MARK	DATE	DESCRIPTIONS	BY	CH'D	CCO#
2	07/12/13	MISCELLANEOUS SCADA CHANGES	RR RSB	RG	305
1	05/13/13	MISCELLANEOUS SCADA CHANGES	RR RSB	RG	305
0	06/23/10	DEHUMIDIFIER SCADA INTERFACE	RR	RG FW	130

CONTRACT CHANGE ORDER NO. 305
SHEET 2 OF 23

DETAILS
TOWER AND SUSPENSION CABLE TOWER POWER AND LIGHTING
NN SCALE

CONNECTION DIAGRAM - DEHUMIDIFICATION #5

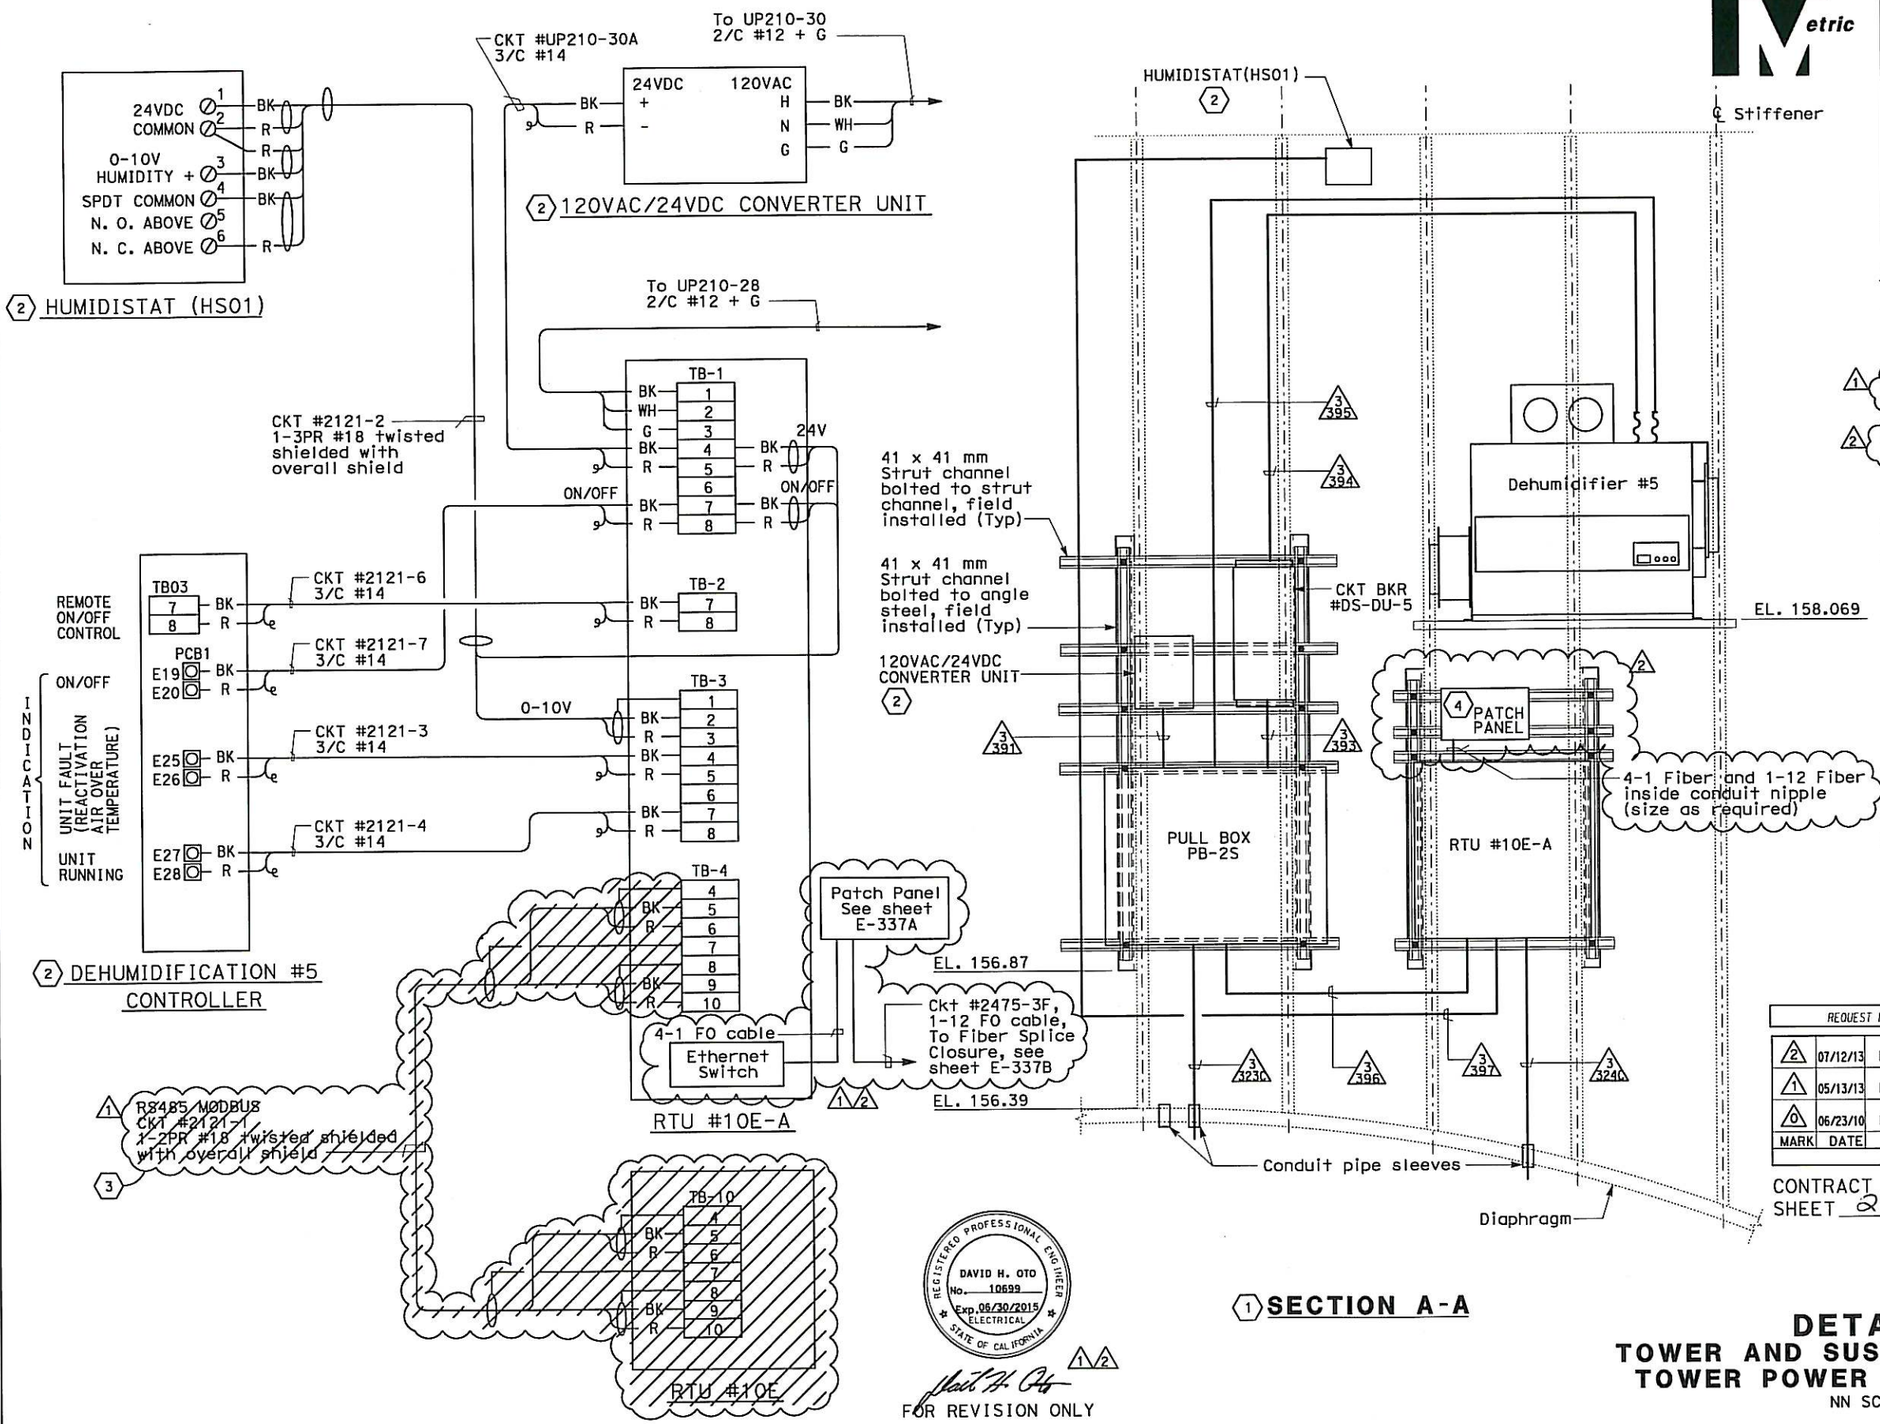
1. For Dehumidification Unit #5 plan drawing, see sheet E-287.
2. Furnished by the Dehumidifier vendor.
3. Abandon in place (hatched items) if installed.
4. Contractor shall locate the equipment and build the support to suit field condition.

DETAILS
SCADA REMOTE TERMINAL UNIT SYSTEM RTU #10W, #10E, #11W AND #11E PANEL LAYOUT

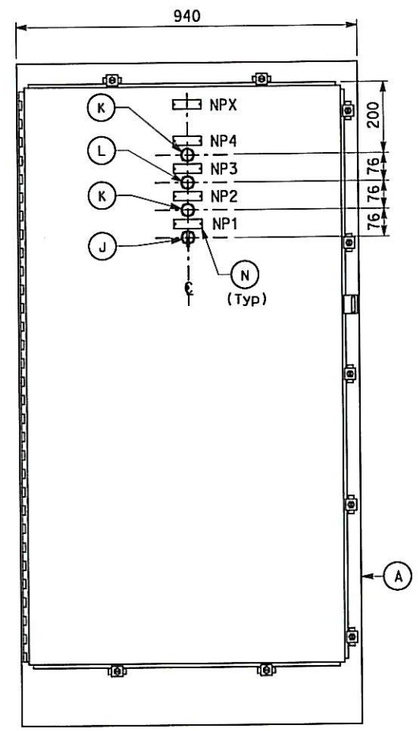
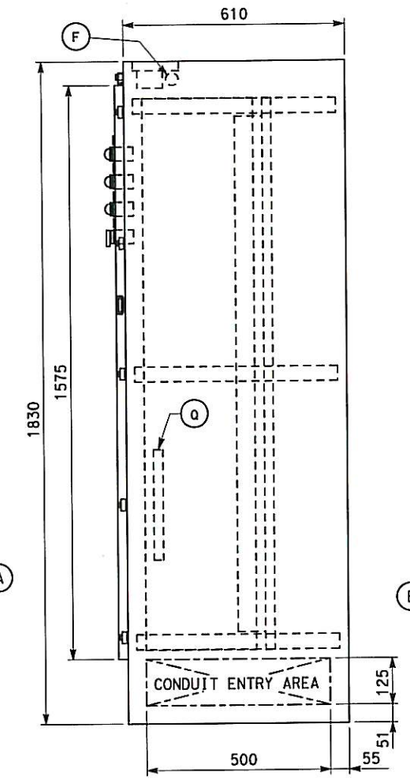
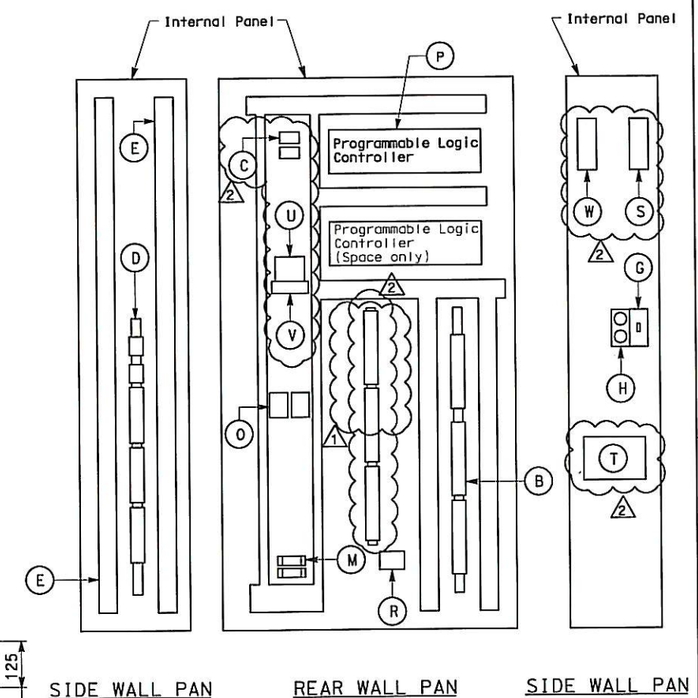
MARK	DATE	DESCRIPTIONS	BY	CH'D	CCO#
2	07/12/13	MISCELLANEOUS SCADA CHANGES	RR RSB	RG	305
1	05/13/13	MISCELLANEOUS SCADA CHANGES	RR RSB	RG	305

DETAILS
SCADA REMOTE TERMINAL UNIT SYSTEM
MAIN TOWER RTU #10E-A PANEL LAYOUT
NO SCALE

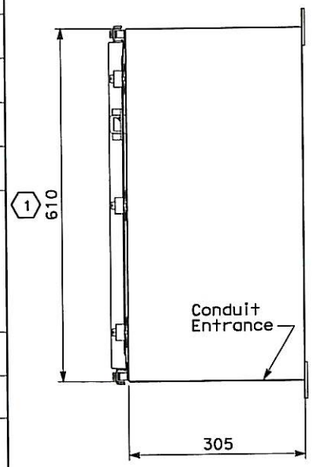
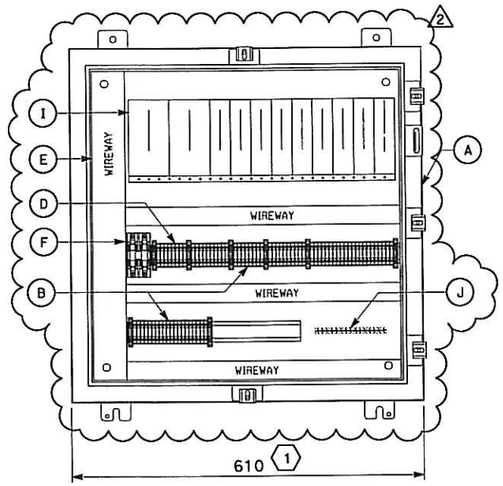
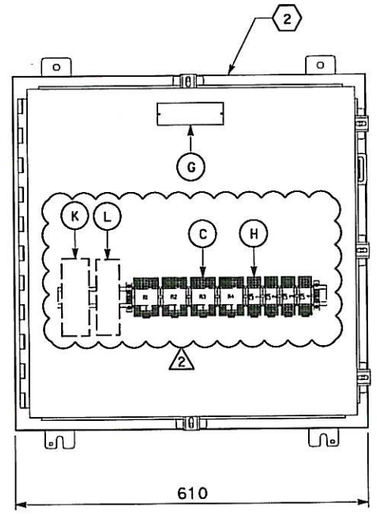
(1) Because of limited space, in the main tower, RTU #10E-A shall be furnished as small as possible with outside dimensions not to exceed 610(H) x 610(W) x 305(D).

MARK	DATE	DESCRIPTIONS	BY	CH'D	CCO#
2	07/12/13	MISCELLANEOUS SCADA CHANGES	RR RSB	RG	305
1	05/13/13	MISCELLANEOUS SCADA CHANGES	RR RSB	RG	305
0	02/01/10	DEHUMIDIFIER SCADA INTERFACE	RG	JE FW	130

SCADA REMOTE TERMINAL UNIT SYSTEM #COM-5 TERMINAL BOX WIRING DIAGRAM

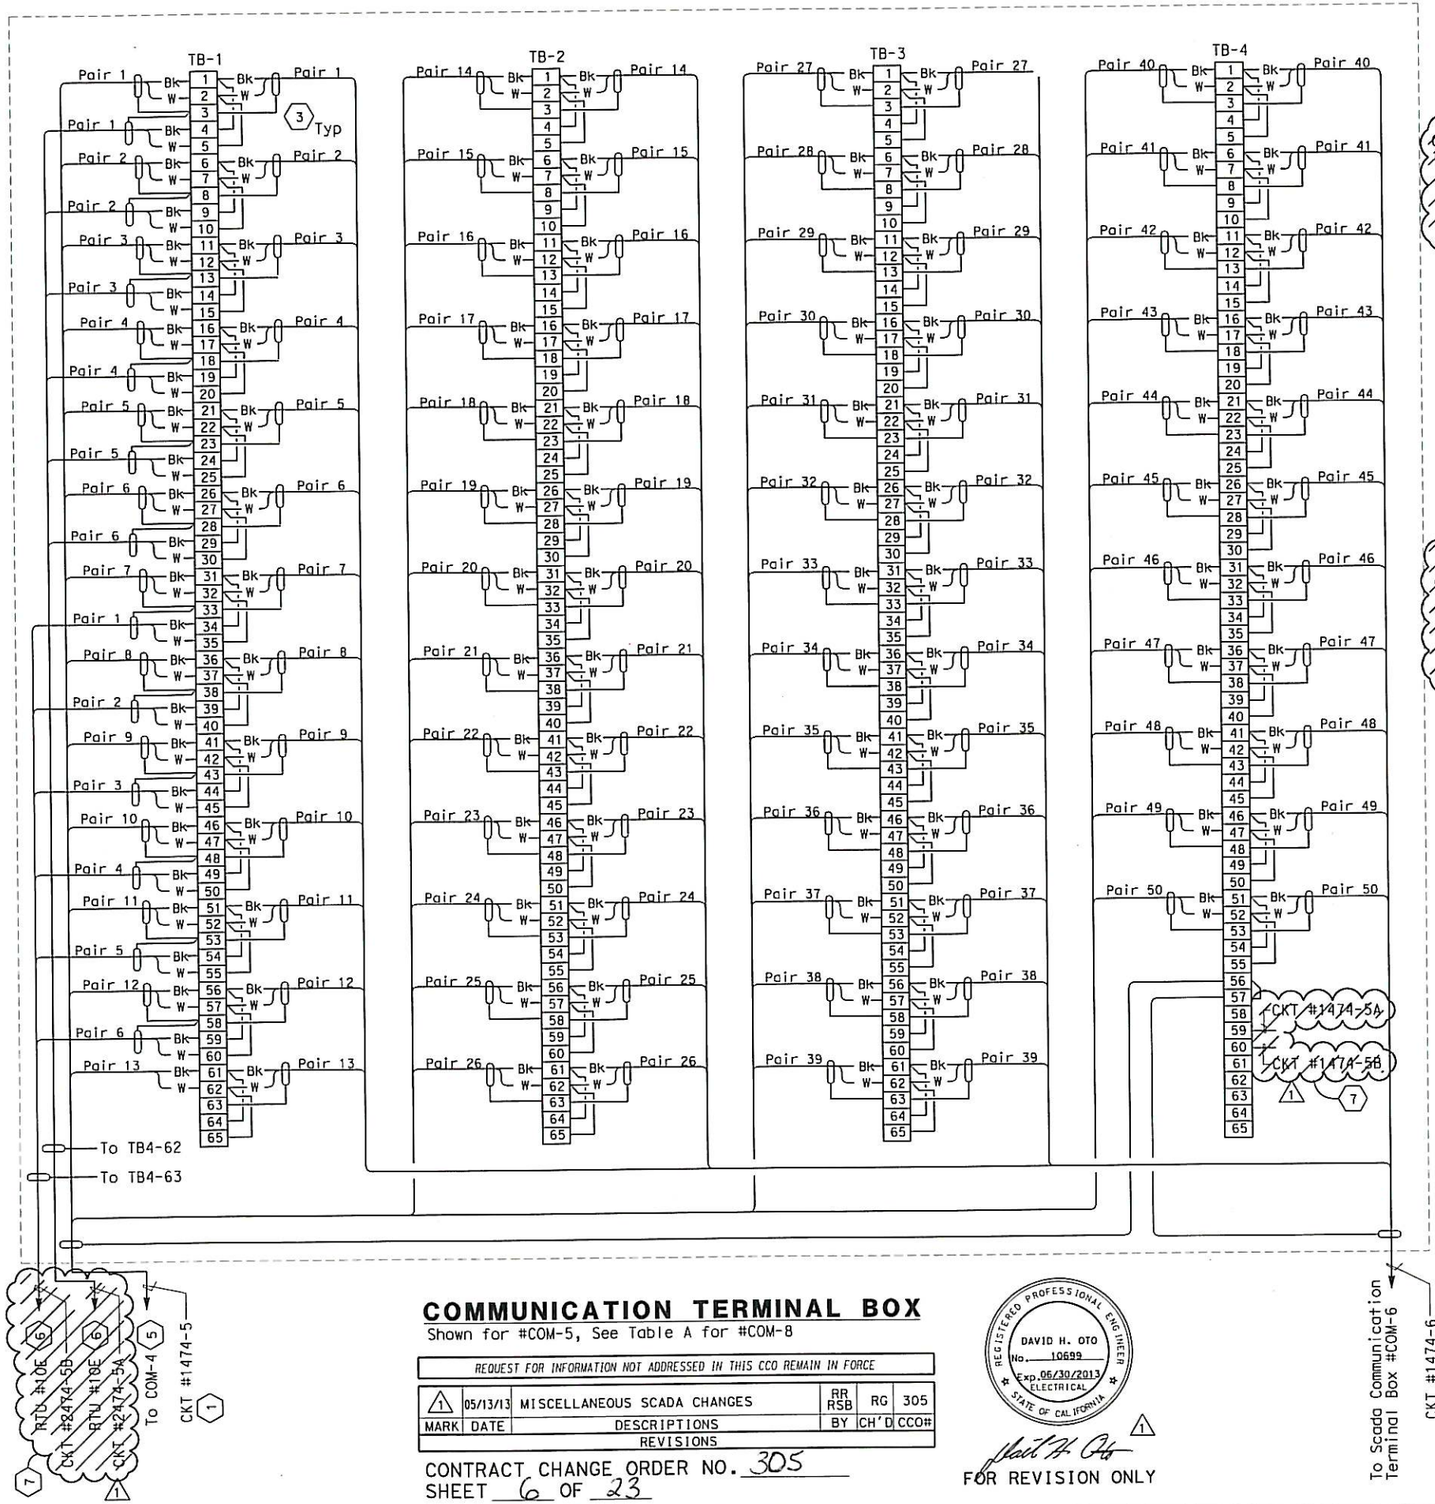
REQUEST FOR INFORMATION NOT ADDRESSED IN THIS CCO REMAIN IN FORCE					
1	05/13/13	MISCELLANEOUS SCADA CHANGES	RR RSB	RG	305
MARK	DATE	DESCRIPTIONS	BY	CH'D	CCO#
		REVISIONS

1. SCADA communication cable 50 pairs #18, shielded pairs and overall shield.
2. RTU communication cable 1-6 pairs shielded and overall shield. 1
3. Individual and overall shields shall be grounded at the interface cabinet only.
4. For RTU #10W connection diagram, see sheet E-330. 1
5. The Contractor shall extend and coil 5 meters of cable in Manhole-27. All cables shall be tagged with circuit numbers as shown. For location of Manhole-27, see sheet E-11.
6. For RTU #10E connection diagram, see sheet E-331. 1
7. Abandon in place (hatched items) if installed.

DETAILS
SCADA REMOTE TERMINAL UNIT SYSTEM #COM-4 TERMINAL BOX WIRING DIAGRAM

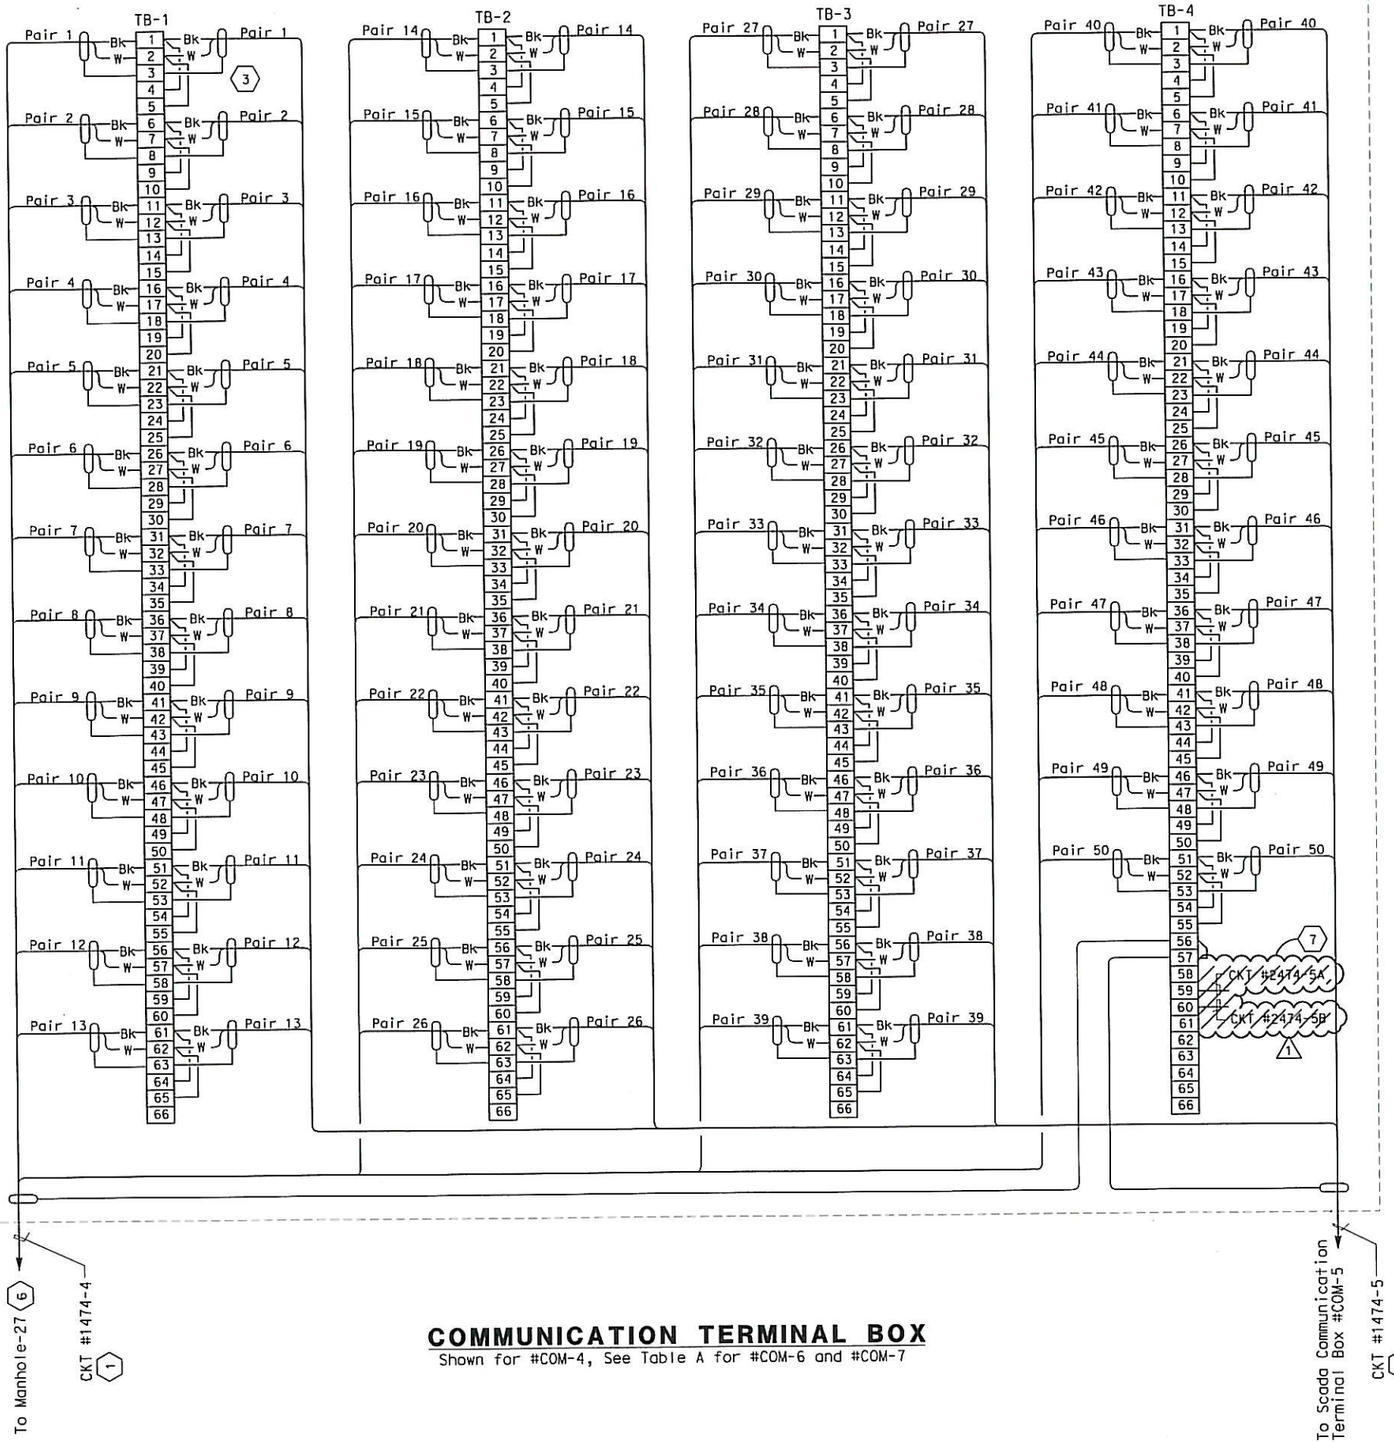
(7) Abandon in place (hatched items) if installed. (1)

MARK	DATE	DESCRIPTIONS	BY	CH'D	CCO#
1	05/13/13	MISCELLANEOUS SCADA CHANGES	RR RSB	RG	305
